SUBJECT: City of Wilsonville Plan Amendment
DLCD File Number 005-13

Amendment to the Villebois Village Master Plan (supporting document of Wilsonville's Comprehensive Plan) to adopt Plan components (land use, parks and open space, utilities, and circulation) for an area designated as "Future Study Area" in the currently adopted Plan. The 42.8 acre "Future Study Area" currently has the same "Residential-Village" Comprehensive Plan Map designation as the rest of the estimated 480 acre Villebois Village Master Plan area.

- Exhibit 1. Conclusionary findings dated September 18, 2013
- Exhibit 2. Summaries of what the amendment does with lists of proposed changes
- Exhibit 3. Villebois Village Master Plan showing changes

Ordinance No. 723 Exhibit 3
Figure 1**NOTES**

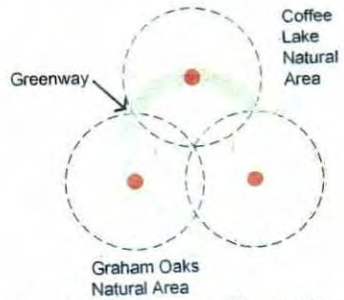
- Figure 1-Land Use Plan
 - Updated Future Study Area on the map by replacing current violet indicating the future study area with colors indicating large, standard, and medium lots as well as indicating a street network consistent with the proposed Figure 7-Street Plan. The pattern of large, standard, and medium colors is consistent with other areas on the edges of Villebois.
 - Update legend/table to indicate additional 12.4 acres being developed as residential lots and alleys.

- Figure 1- Land Use Plan
 - Indicated 7.2 of the former 19.6 acres for the Future Study Area as additional public right-of-way
- Figure 7- Street Plan
 - Add preliminary street and trail network for the Future Study Area indicating planned cross sections.
 - Add new "Residential-Median" cross section to street types list.
- Figure 9-B- Street and Trail Sections – B
 - Add section for "Residential-Median" street type.

Figure 6

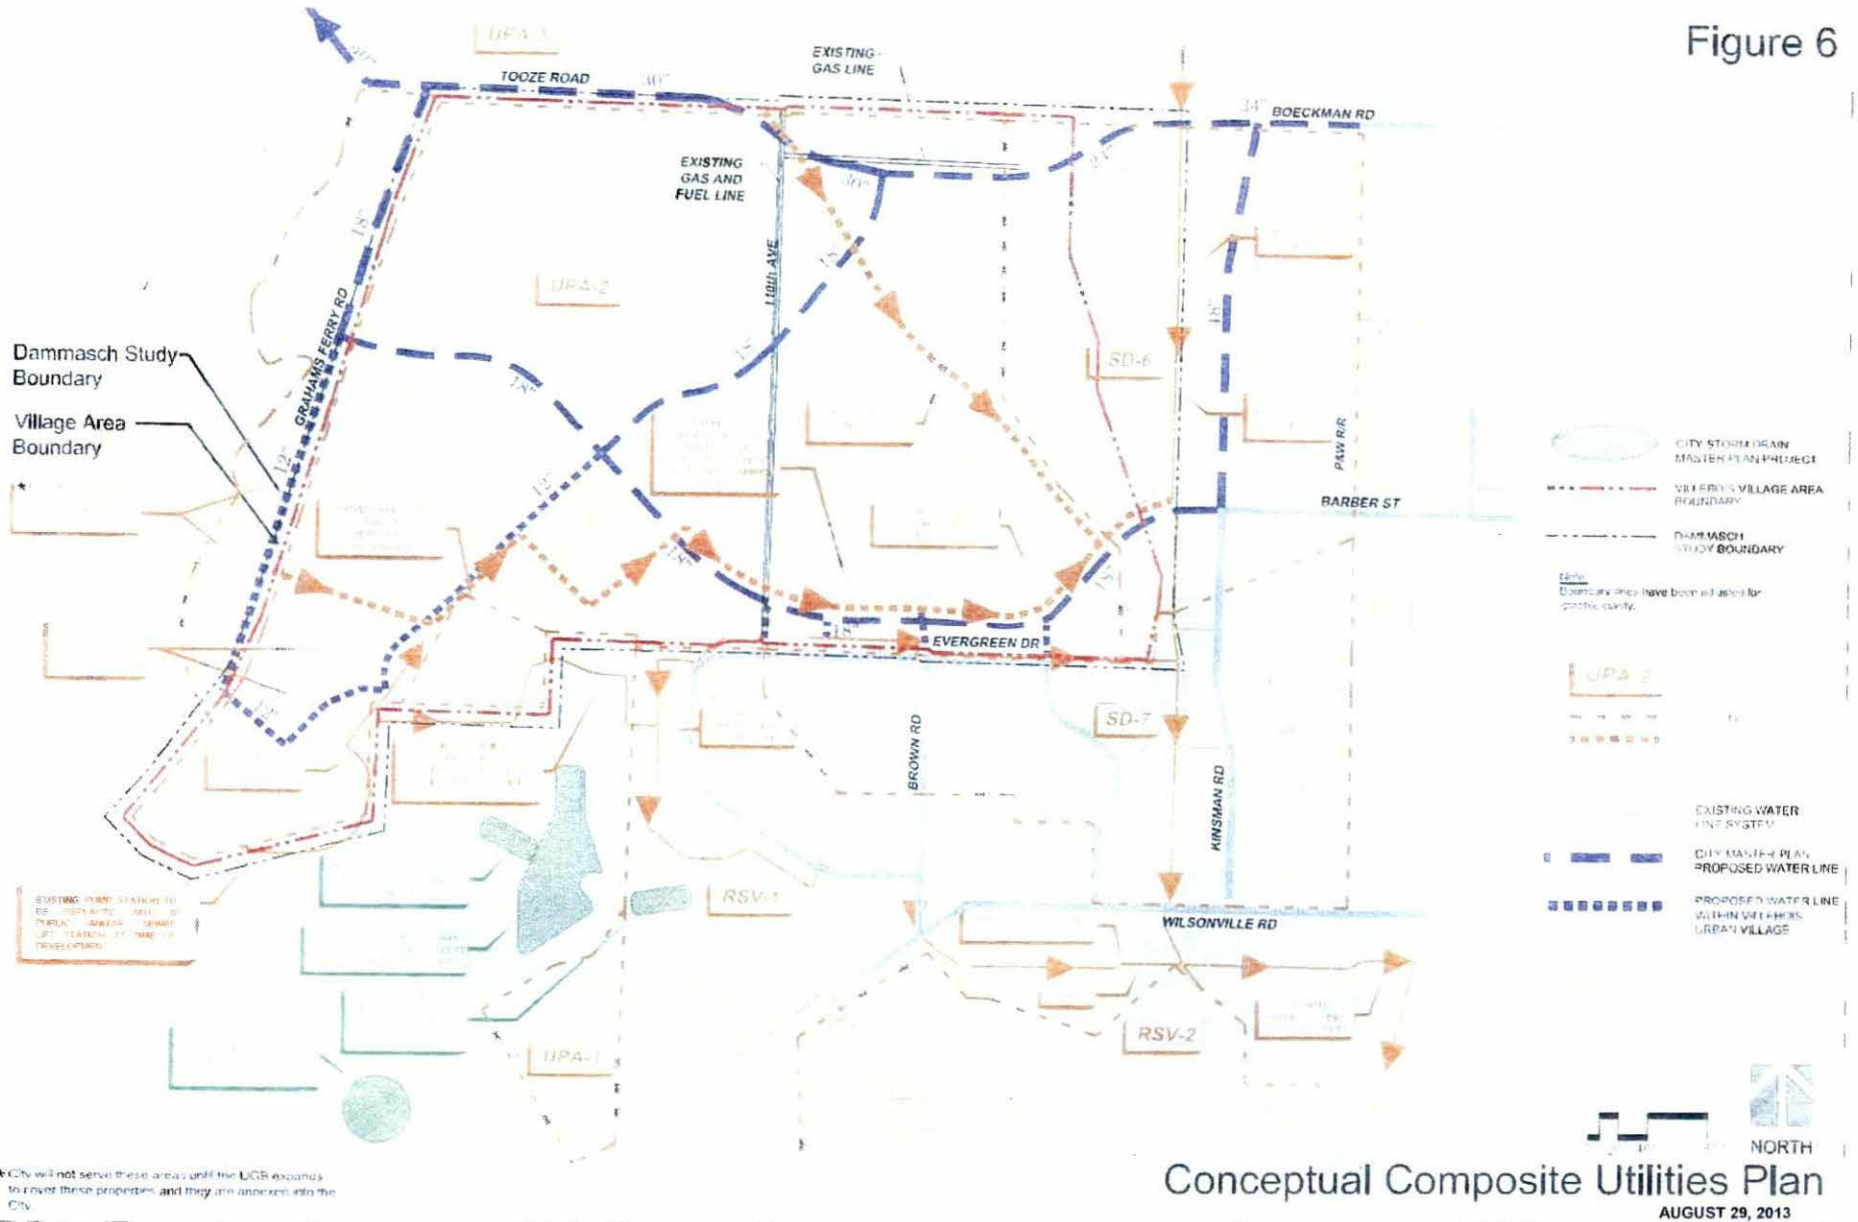
- Figure 6 – Conceptual Composite Utility Plan
 - Change label reading “Existing Pump Station for LEC” to “Existing Private Pump Station to be replaced with Public Sanitary Sewer Lift Station.”

Figure 7

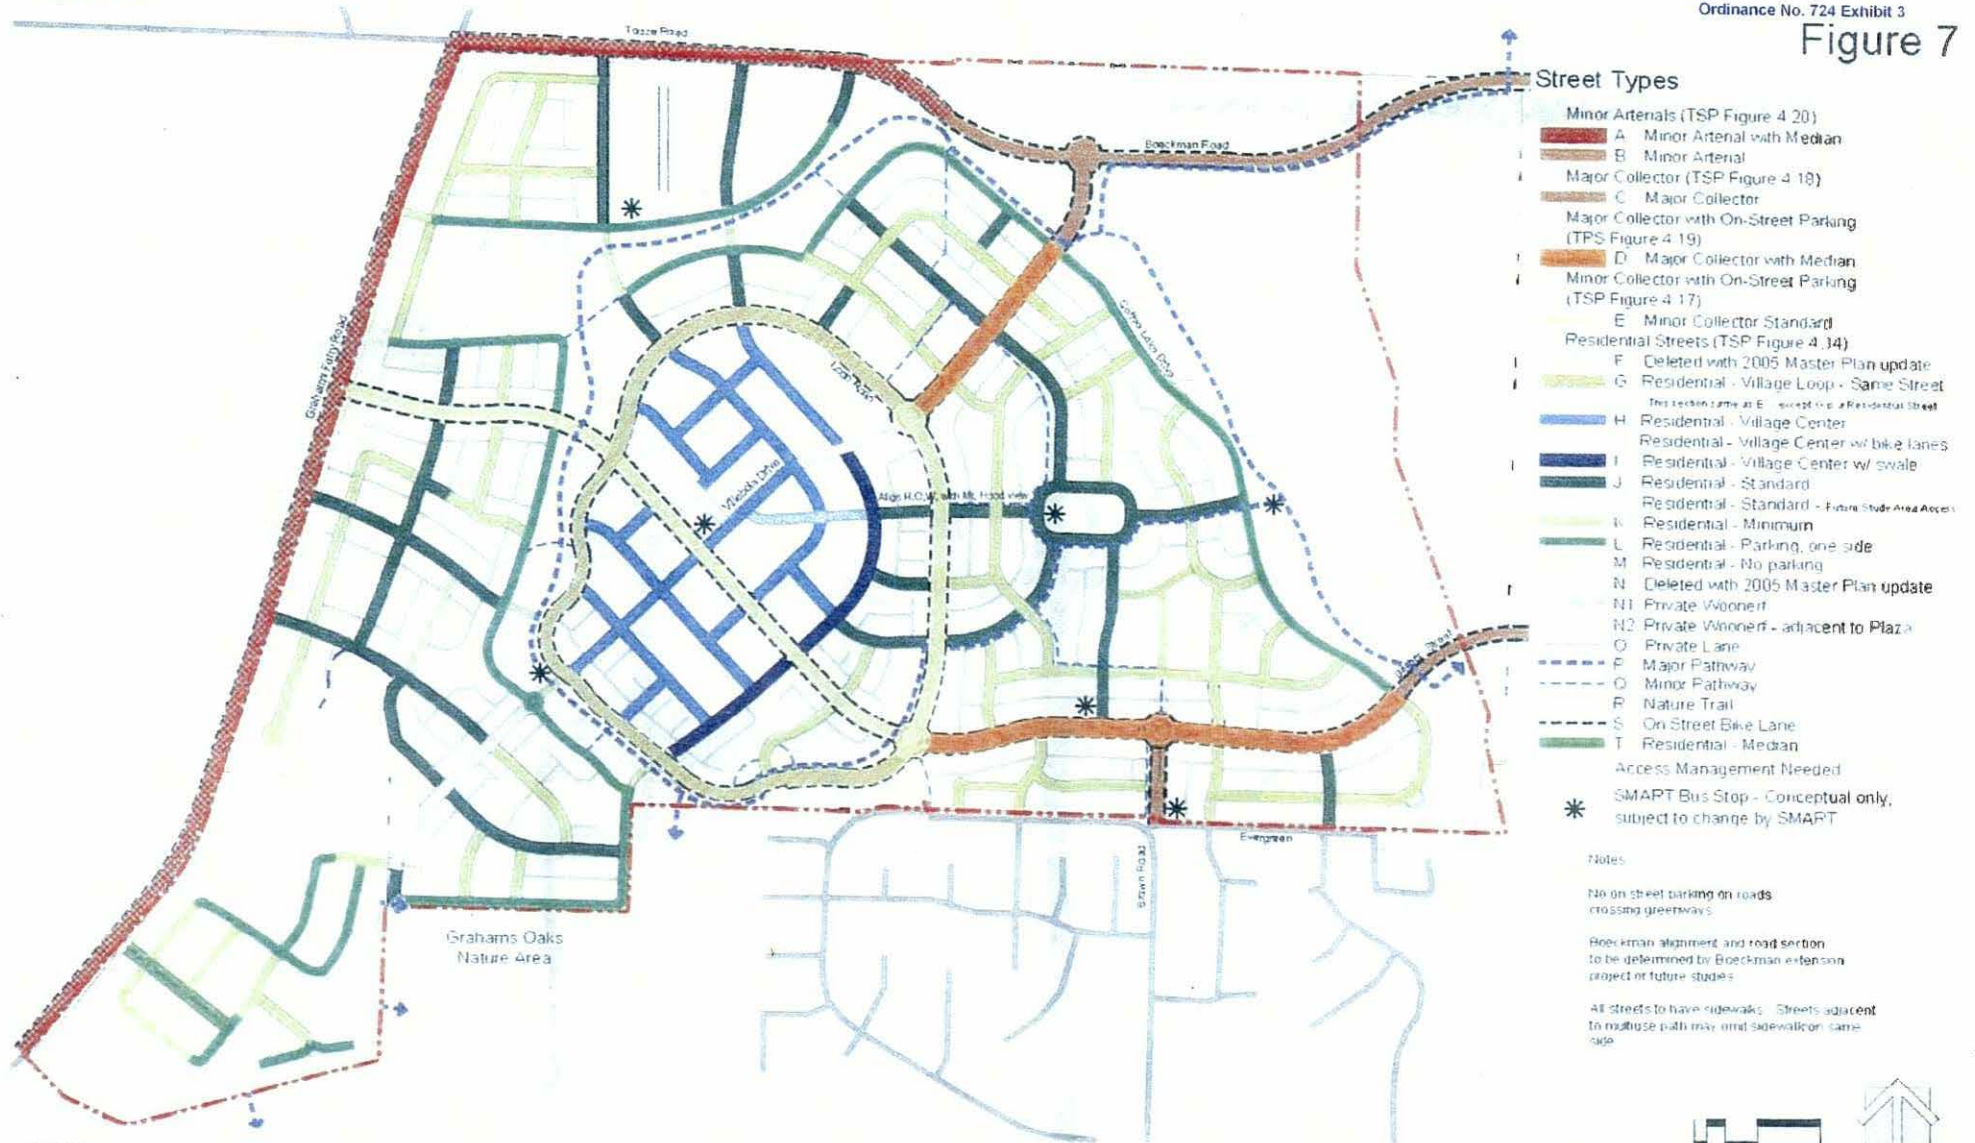
- Figure 5A – Parks and Open Space Plan, Figure 7 – Street Plan
 - Add trail connection from Normandy Lane at Villebois Drive to nature trails in Future Study Area.

Nature Trail Connectivity [Chapter 5, page 69, Continuity of Streets and Trails and Figure 5]

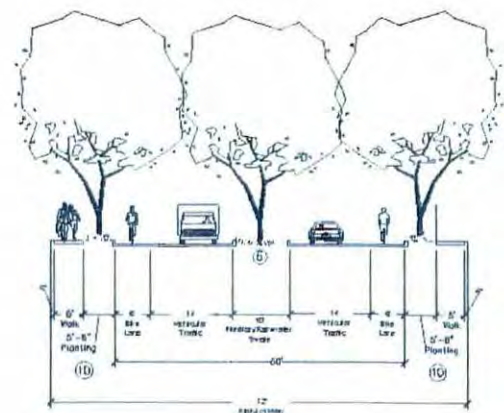
Nature trail connection stubs from SW Grenoble Street and SW San Remo Court were shown on the currently adopted Parks and Open Space Plan (Figure 5) that are located north of the LEC property. The applicant shows these nature trail connections in their revised Figure 5 dated July 26, 2013. This revised plan also shows east and south connections from the internal Villebois nature trail to the Coyote Way Trail that is adjacent to the LEC property which is appropriate. We recommend one additional connection of the Villebois nature trail to the sidewalk on SW Normandy Lane. This additional connection is shown in the Appendix.

Recommendation: Figure 5 should be updated to show the planned nature trail connectivity as identified by the applicant with the addition of a trail connection to SW Normandy Lane. Add a third paragraph to the Continuity of Streets and Trails subsection in Chapter 5 as follows:

Provide nature trail connections between the LEC property and SW San Remo Court, SW Grenoble Street, and Normandy Lane. Also provide east and south trail connections from the LEC property to the Coyote Way Trail within Grahams Oak Nature Park.
